Technical Memorandum

Project: 20-2737.0406

Re: Water System Capacity Analysis – Herman Road Industrial Park

Figure 1. Proposed Industrial Development Site and Water System Infrastructure

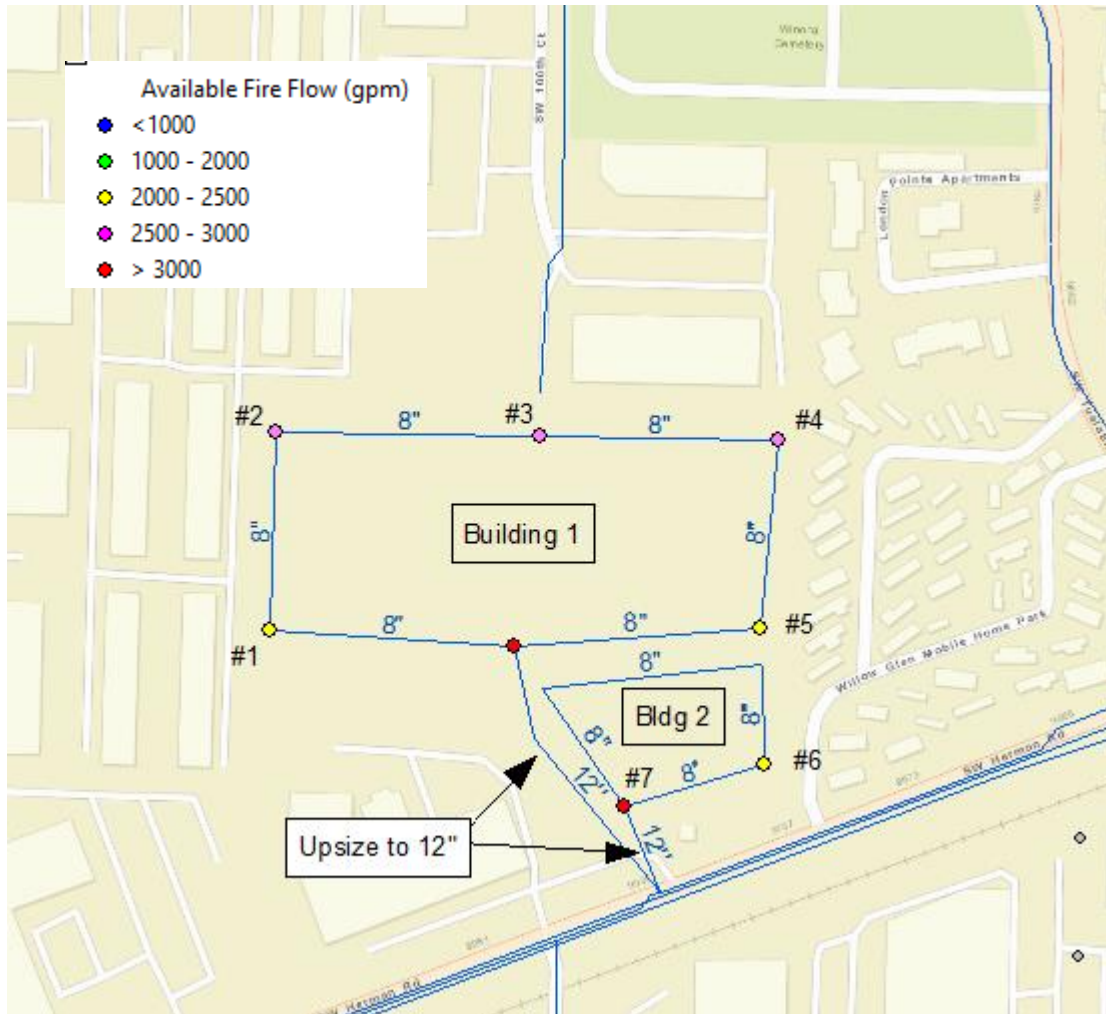
Available fire flow was modeled at the seven proposed fire hydrant locations onsite (shown in Figure 1). Hydrants 1-5 were evaluated at 1,688 gpm, and hydrants 6 and 7 were evaluated at 1,500 gpm fire flow. Conditions were run under 2040 Maximum Day Demand (MDD), low flow rates from Portland supply PRVs, and existing conditions plus the proposed onsite piping.

Based on the findings of this analysis and a review of overall system improvement needs presented in the Water System Master Plan, there are no additional required water distribution system improvements necessary to serve fire suppression flows to the proposed development.

However, the single 8-inch connections to Herman Road should be upsized to 12-inch diameter to meet fire flow velocity requirements. The proposed 8-inch diameter looped mains are adequate to serve expected fire flow demands at both properties.
